EVALUATION OF DOD WASTE SITE GROUNDWATER
PUMP-AND-TREAT OPERATIONS

Report Number 98-090

SUBJECT: Evaluation Report on DoD Waste Site Groundwater Pump-and-Treat
Operations (Report No. 98-090)

SUBJECT: Review and Comment of Evaluation Report on Department of Defense
Waste Site Groundwater Pump-and-Treat Operations (Project No. 6CB-0057)

Figure 2: Total Annual Operations and Maintenance Plus Monitoring Costs

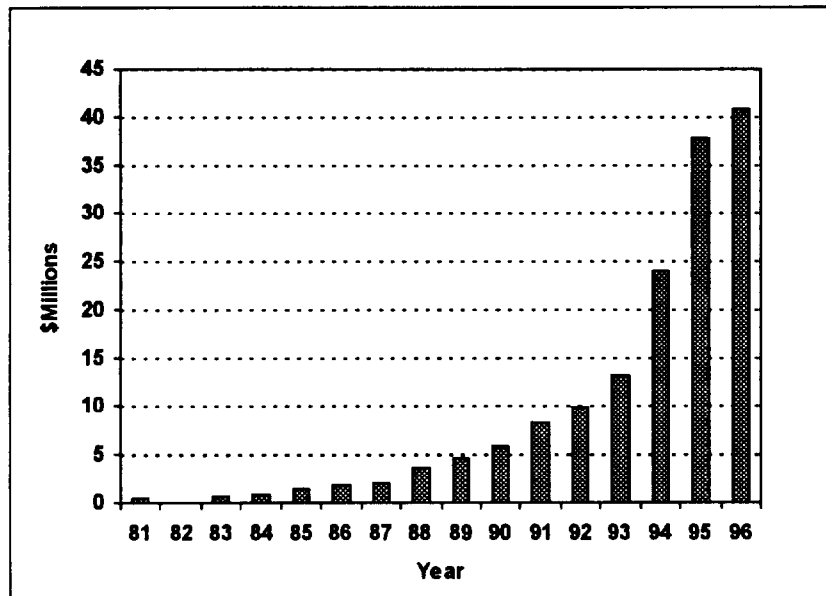
r. Page 10, first paragraph, last sentence. The conclusion reached in this sentence does not necessarily follow from the figure below it. The total costs presented in Figure 2 are a function of the total number of systems in operation. Much of the increase in O&M costs after 1994 is the result of 24 additional systems being brought online in 1995 and 1996. Therefore it is misleading to imply that O&M costs will continue to increase at the same rate as that shown in the figure when the number of new pump and treat systems is declining (only 7 systems brought online in 1996 compared to 17 systems in 1995).

Revised
